**CONSENT ITEM B-4**

Consider Approval of Change Order #5 to the Site Access Improvements at Various Elementary Schools Ph. 2 project.

DATE: 12/2/25 CO #: Five (05)  
TO: Redlee Construction & PROJECT: Oldham Co. Elementaries Site  
Development, Inc. & Access Imp. – Phase 2  
800 Stonecreek Parkway, Suite 5A Oldham County, Kentucky  
Louisville, Kentucky 40223 BG 24-109  
RTA 23050  
CONTRACT DATE: September 20, 2024 CONTRACT FOR: General Construction

Re: 23050 | OCBE | OC Elementaries: Site Access Improvements – Phase 2 | Goshen-FO-013  
Fence Changes

Remediation of Buckner Elementary Playground Area

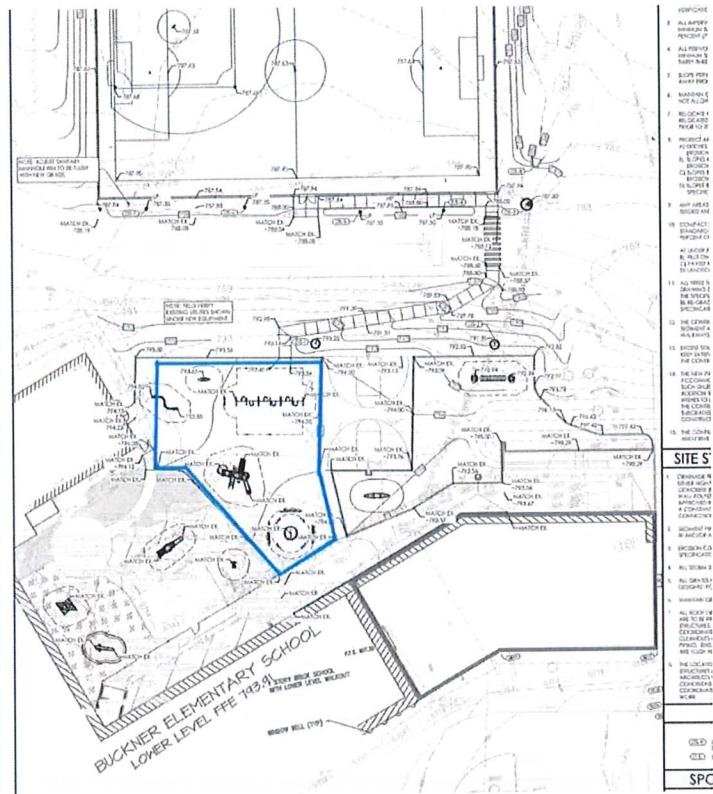
By the directive of Redlee Construction and per the Field Report dated March 28, 2025 by Solid Ground Consulting Engineers and under their supervision the following remediation of unsuitable soils was performed at Buckner Elementary.

Undercut of ~~322~~ cu yards of unsuitable and debris laded materials.

Replaced with 8" compacted lifts of DGA.

Figure 1: Crestwood Elementary Test Pit Locations

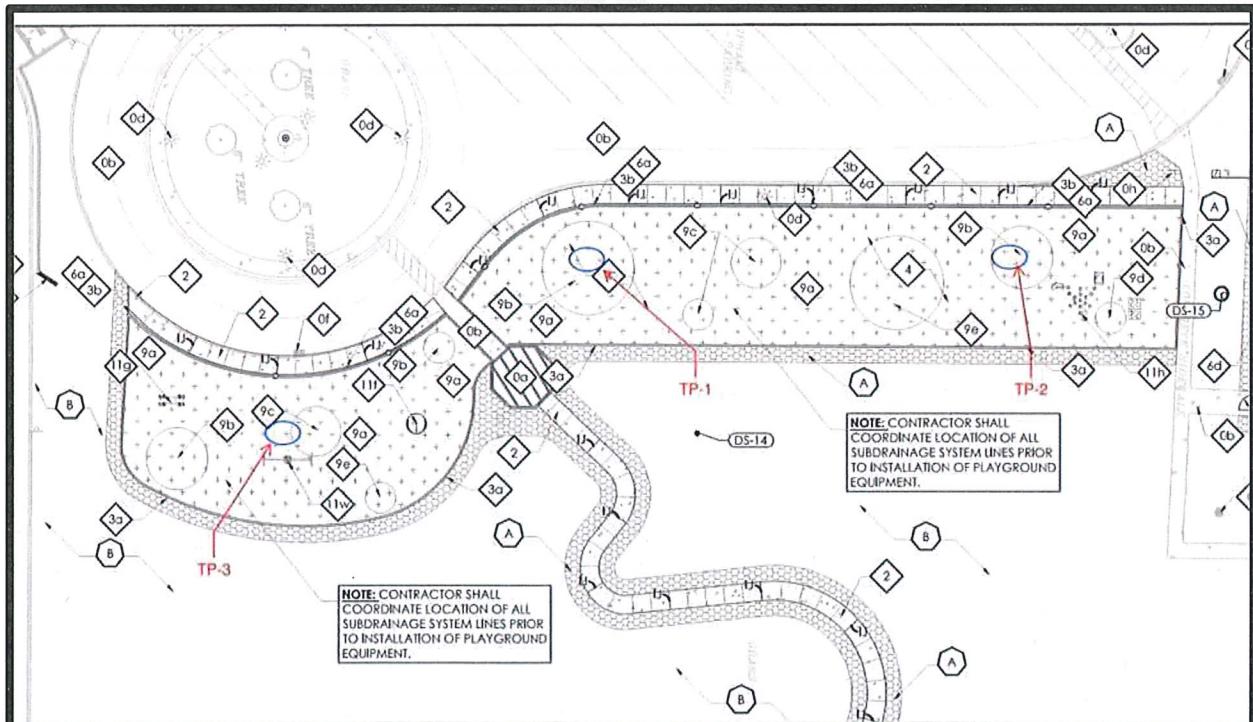
The new playgrounds were generally at or slightly high (4-6") of subgrade elevation. A proof roll with a single axle dump truck was performed. Rutting and pumping of up to 6" was observed. Three test pits were excavated to depths ranging from 16" to 30". Figure 1 below shows the approximate locations of the test pits. The test pits generally showed fill material throughout. A layer of asphalt was observed in all test pits at depths ranging from 8" to 16". In addition, there were some pieces of construction debris observed. Stiff, silty Clay was encountered at termination depths of all three test pits.

We recommend that the playgrounds be undercut 12" or to where stiff clay is encountered, whichever is less. A proof roll should be performed after the undercut is completed and before any backfill is placed. Backfill material may consist of engineered fill soil or dense graded aggregate (DGA) compacted in 8" loose lifts. A sheepfoot compactor should be used for clay and a smooth drum roller should be used for DGA. Roller compactors should weigh a minimum of 10 tons. The use of #57 stone is appropriate for use as fill at elevations above the top of the drains.

Figure 2: Camden Station Site Conditions

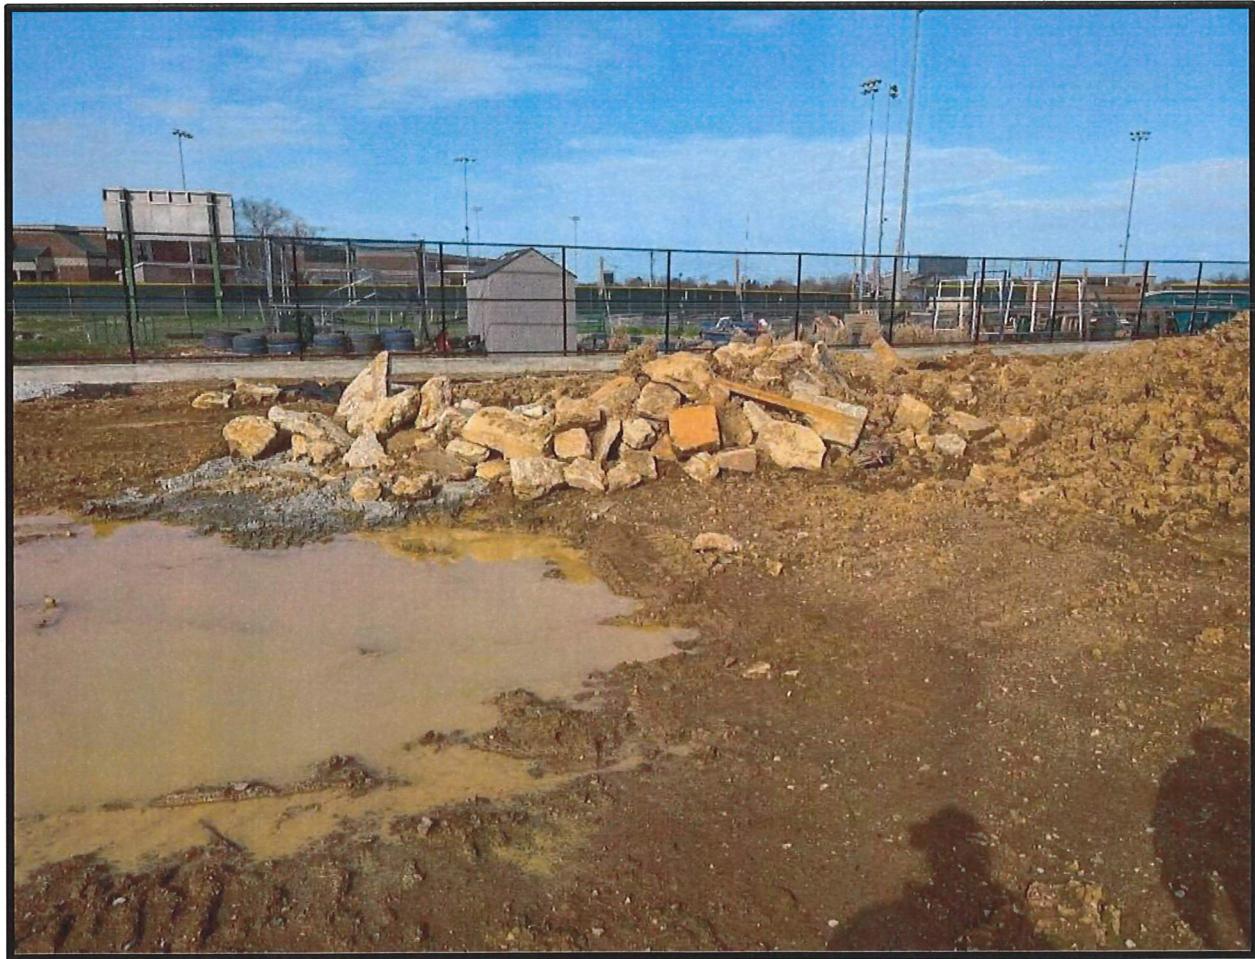
The new playground was generally at or below (12") subgrade elevation. There was standing water and large boulders and cobbles visible during the site walk. A test pit was excavated towards the rear of the playground to a depth of 24". The upper 12" of the subgrade consisted of a soft, wet dark brown clayey silt before increasing in consistency to stiff. Figure 2 shows the general site conditions.

We recommend that the playground be undercut 12" to remove the soft saturated soil. Any boulders or cobbles visible after the undercut should be

Figure 1: Crestwood Elementary Test Pit Locations

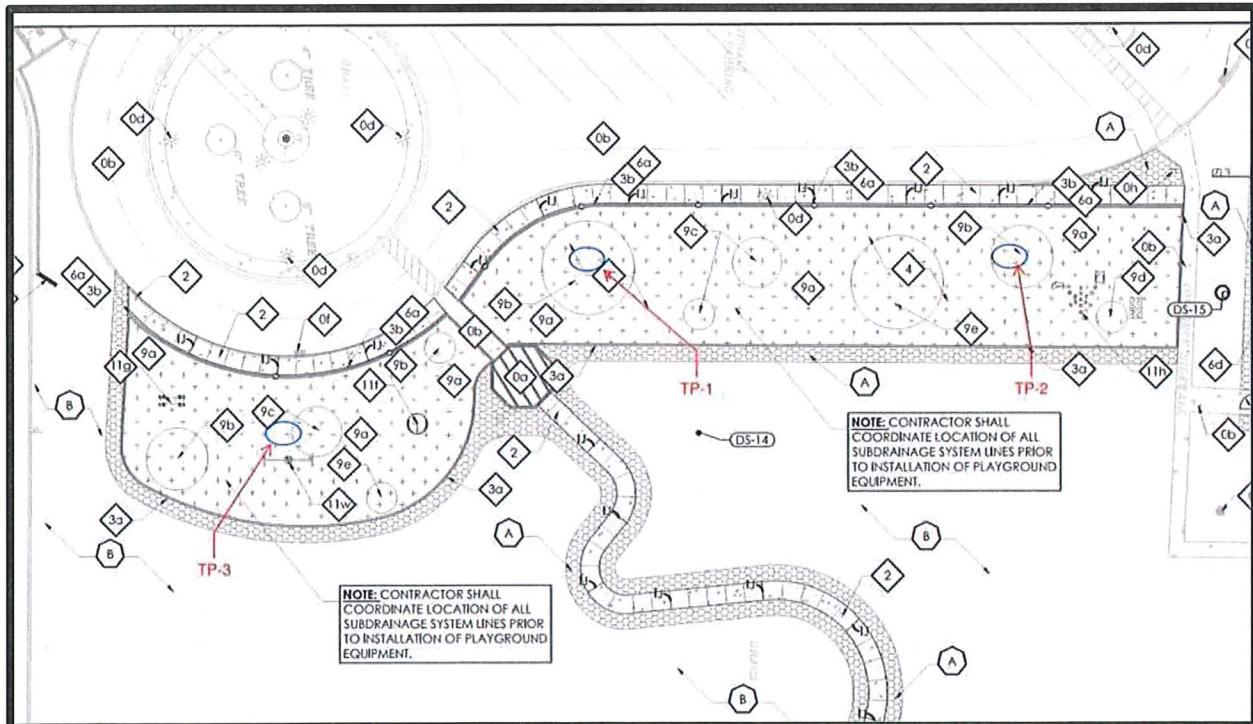
The new playgrounds were generally at or slightly high (4-6") of subgrade elevation. A proof roll with a single axel dump truck was performed. Rutting and pumping of up to 6" was observed. Three test pits were excavated to depths ranging from 16" to 30". Figure 1 below shows the approximate locations of the test pits. The test pits generally showed fill material throughout. A layer of asphalt was observed in all test pits at depths ranging from 8" to 16". In addition, there were some pieces of construction debris observed. Stiff, silty Clay was encountered at termination depths of all three test pits.

We recommend that the playgrounds be undercut 12" or to where stiff clay is encountered, whichever is less. A proof roll should be performed after the undercut is completed and before any backfill is placed. Backfill material may consist of engineered fill soil or dense graded aggregate (DGA) compacted in 8" loose lifts. A sheepfoot compactor should be used for clay and a smooth drum roller should be used for DGA. Roller compactors should weigh a minimum of 10 tons. The use of #57 stone is appropriate for use as fill at elevations above the top of the drains.

Figure 2: Camden Station Site Conditions

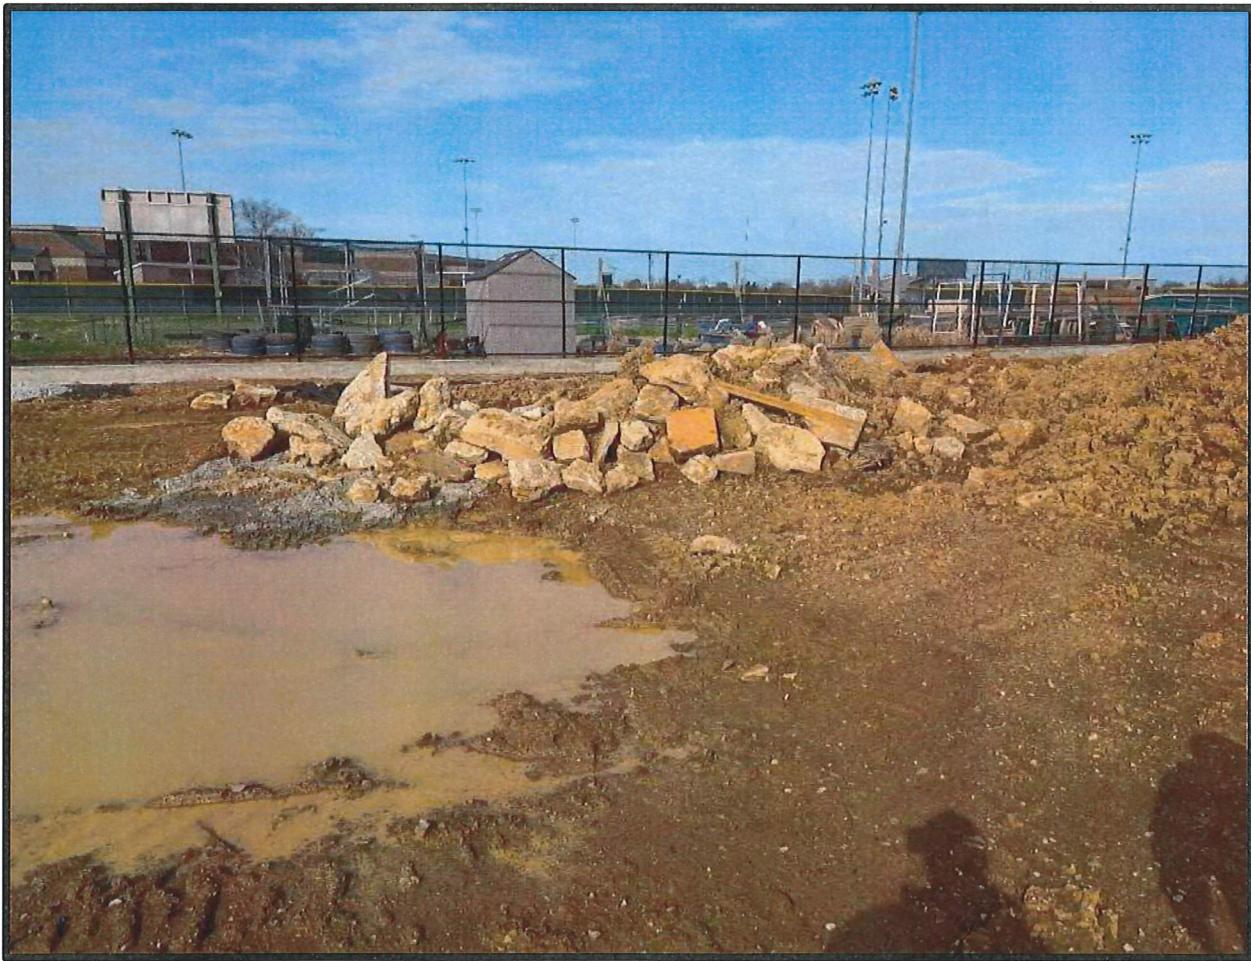
The new playground was generally at or below (12") subgrade elevation. There was standing water and large boulders and cobbles visible during the site walk. A test pit was excavated towards the rear of the playground to a depth of 24". The upper 12" of the subgrade consisted of a soft, wet dark brown clayey silt before increasing in consistency to stiff. Figure 2 shows the general site conditions.

We recommend that the playground be undercut 12" to remove the soft saturated soil. Any boulders or cobbles visible after the undercut should be

Figure 1: Crestwood Elementary Test Pit Locations

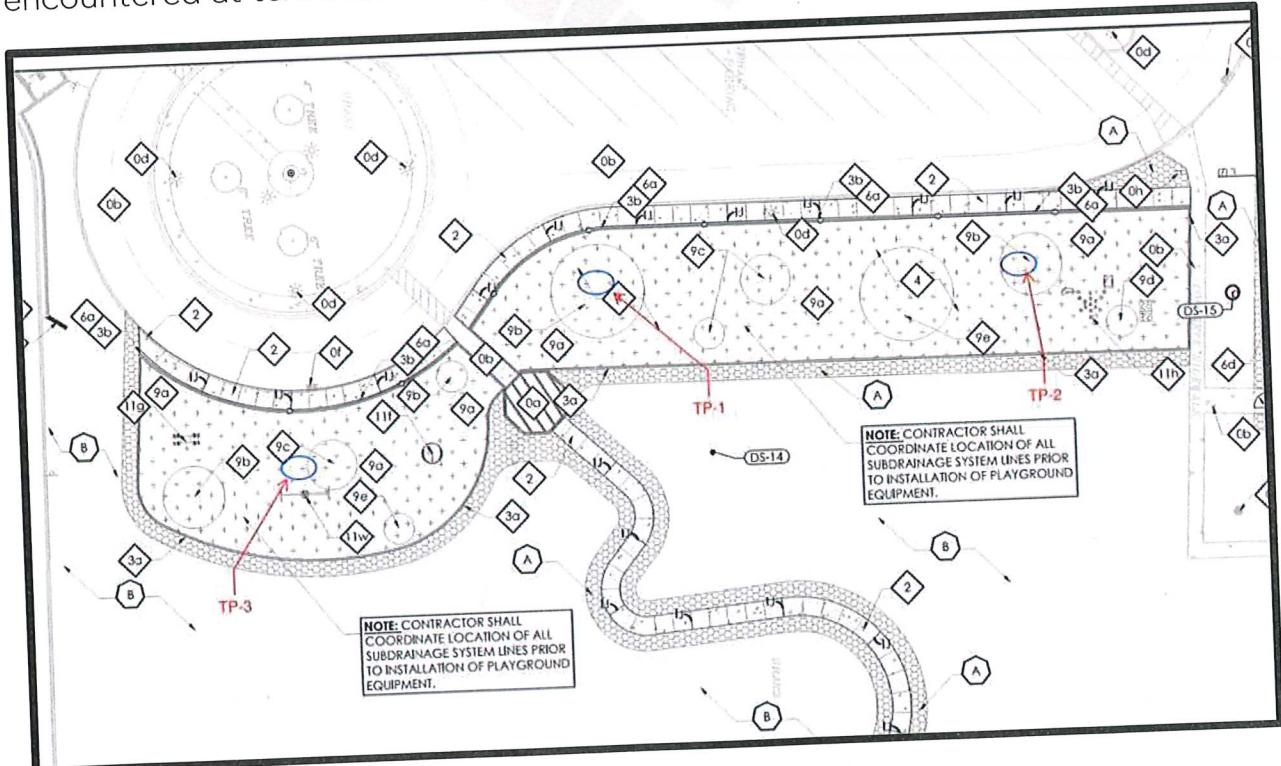
The new playgrounds were generally at or slightly high (4-6") of subgrade elevation. A proof roll with a single axle dump truck was performed. Rutting and pumping of up to 6" was observed. Three test pits were excavated to depths ranging from 16" to 30". Figure 1 below shows the approximate locations of the test pits. The test pits generally showed fill material throughout. A layer of asphalt was observed in all test pits at depths ranging from 8" to 16". In addition, there were some pieces of construction debris observed. Stiff, silty Clay was encountered at termination depths of all three test pits.

We recommend that the playgrounds be undercut 12" or to where stiff clay is encountered, whichever is less. A proof roll should be performed after the undercut is completed and before any backfill is placed. Backfill material may consist of engineered fill soil or dense graded aggregate (DGA) compacted in 8" loose lifts. A sheepfoot compactor should be used for clay and a smooth drum roller should be used for DGA. Roller compactors should weigh a minimum of 10 tons. The use of #57 stone is appropriate for use as fill at elevations above the top of the drains.

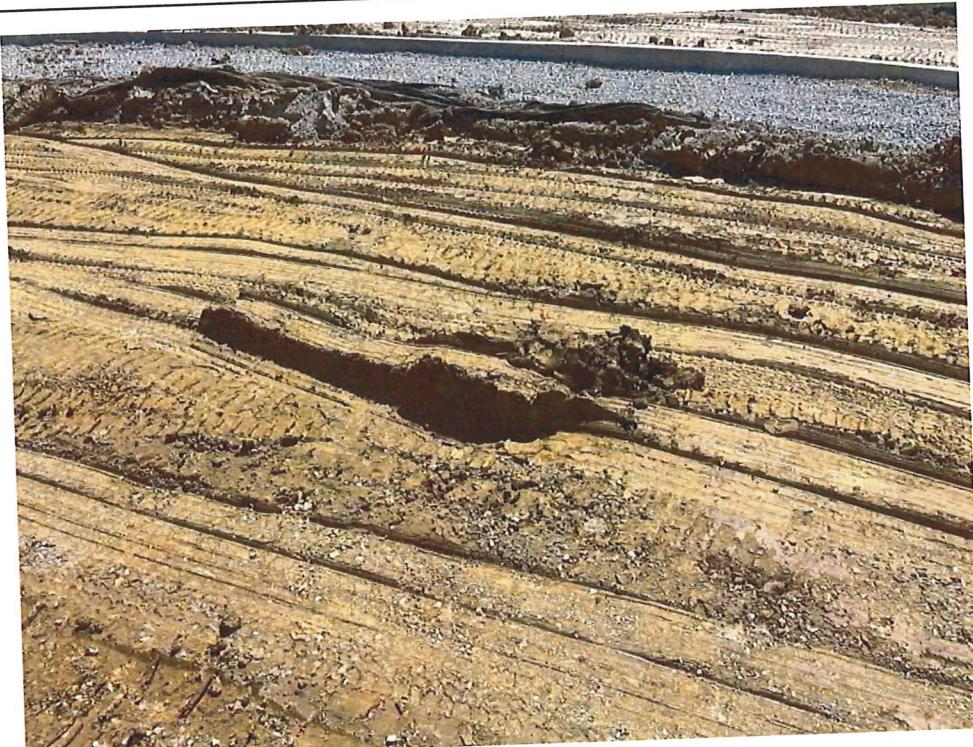
Proof roll with loaded truck shows soft soils in excess of recommend 12" undercut in 12' by 12' area. All other areas show material stiff with minimal amounts of rutting no more than 2".
